Wisconsin Department of Transportation

<p>Proposal #23: 6170-00-61 C Wautoma, S Cambridge St STH 22 to STH 22 N STH 21 Waushara County</p>	<p>6310-00-60, WISC 2021 180 Princeton - Plainfield STH 22 to CTH BB STH 73 Waushara County</p>
<p>6321-00-72, WISC 2021 181 Plainfield – Wisconsin Rapids CTH BB to 5th Ave STH 73 Waushara County</p>

This is Addendum No. 01, which provides for the following:

ADDENDUM NO. 01
6170-00-61, 6310-00-60, & 6321-00-72
February 2, 2021

Figure 1: Nuclear/Core Correlation Location Layout

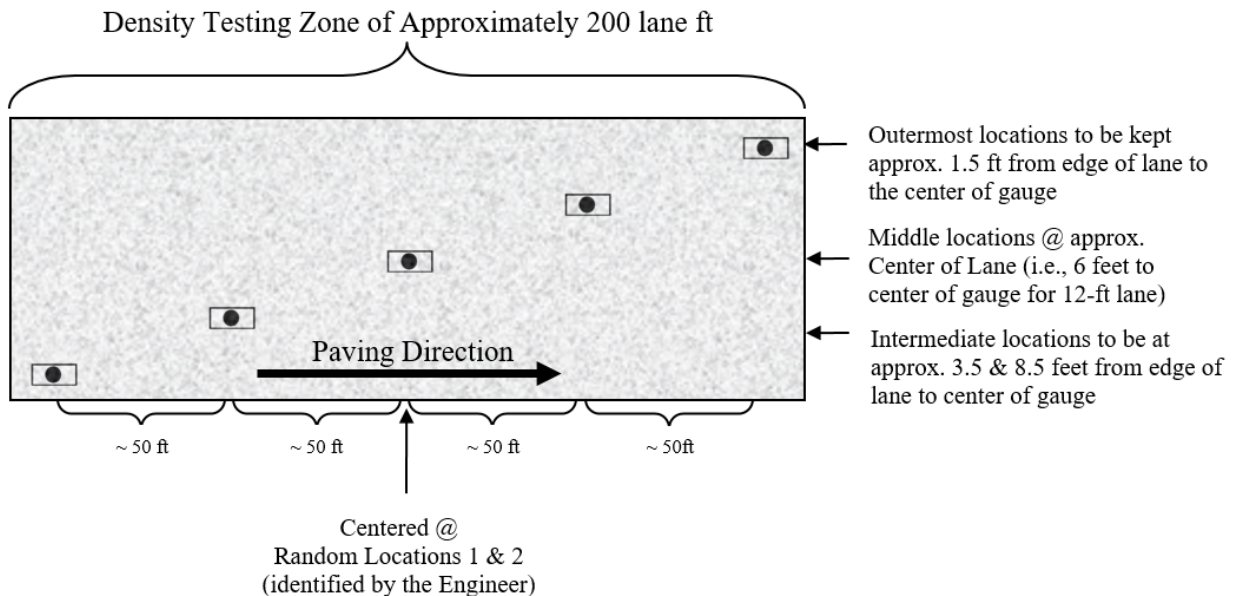
The engineer will identify two zones in which gauge/core correlation is to be performed. These two zones will be randomly selected within each *half* of the test strip length. (Note: Density zones shall not overlap and must have a minimum of 100 feet between the two zones; therefore, random numbers may be shifted (evenly) in order to meet these criteria.) Each zone shall consist of five locations across the mat as identified in Figure 1. The following shall be determined at each of the five locations within both zones:

Individual locations are represented by the  symbol as seen in Figure 1 above. The symbol is two-part, comprised of the nuclear test locations and the location for coring the pavement, as distinguished here:

Each core 150 mm (6 inches) in diameter will be taken at locations as identified in Figure 1. Each random core will be full thickness of the layer being placed. The contractor is responsible for thoroughly drying cores obtained from the mat in accordance with ASTM D 7227 prior to using specimens for in-place density determination in accordance with AASHTO T 166 as modified by CMM 8-36.6.5.

Figure 4: Locations of main lane HMA density testing (QC=solid lines, QV=dashed)

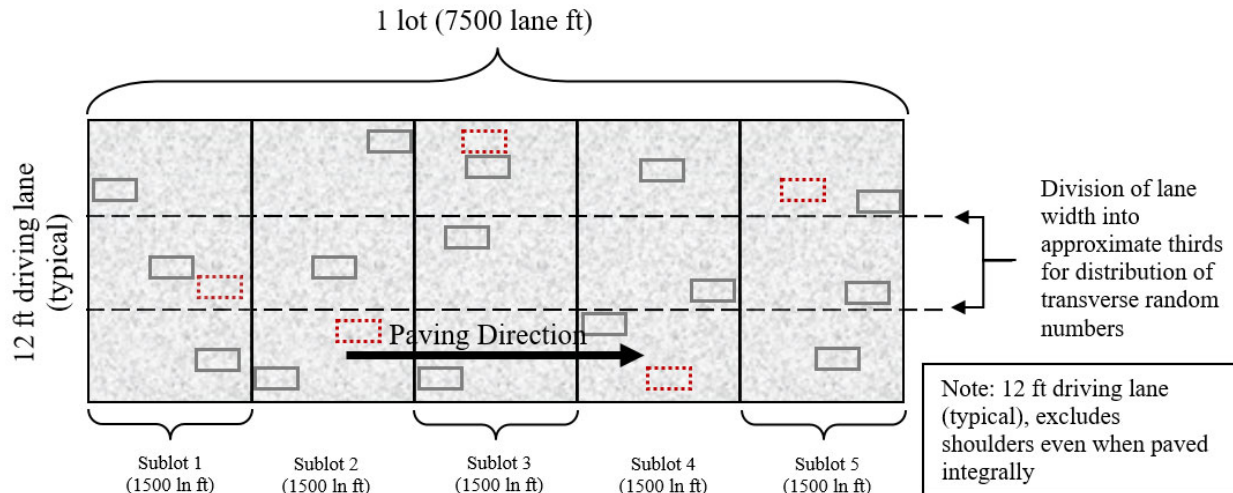
For nuclear density testing of the pavement beyond the test strip, QC tests will be completed at three locations per subplot, with a subplot defined as 1500 lane feet. The three locations will represent the outside, middle, and inside of the paving lane (i.e., the lane width will be divided into thirds as shown by the dashed longitudinal lines in Figure 3 and random numbers will be used to identify the specific transverse location within each third in accordance with CMM 8-15). Longitudinal locations within each subplot shall be determined with 3 independent random numbers. The PWL Density measurements do not include the shoulder and other appurtenances. Such areas are tested by the department and are not eligible for density incentive or disincentive. Each location will be measured with two one-minute gauge readings oriented 180 degrees from one another, in the same footprint as detailed in Figure 2 above. Each location requires a minimum of two readings per gauge. The density gauge orientation for the first test will be with the source rod towards the direction of paving. QV nuclear testing will consist of one randomly selected location per subplot. The QV is also comprised of two one-minute readings oriented 180 degrees from one another. For both QC and QV test locations, if the two readings exceed 1.0 pcf of one another, a third reading is conducted in the same orientation as the first reading. In this event, all three readings are averaged, the individual test reading of the three which falls farthest from the average value is discarded, and the average of the remaining two values is used to represent the location for the gauge. The subplot density testing layout is depicted in Figure 4, with QC test locations shown as solid lines and QV as dashed.
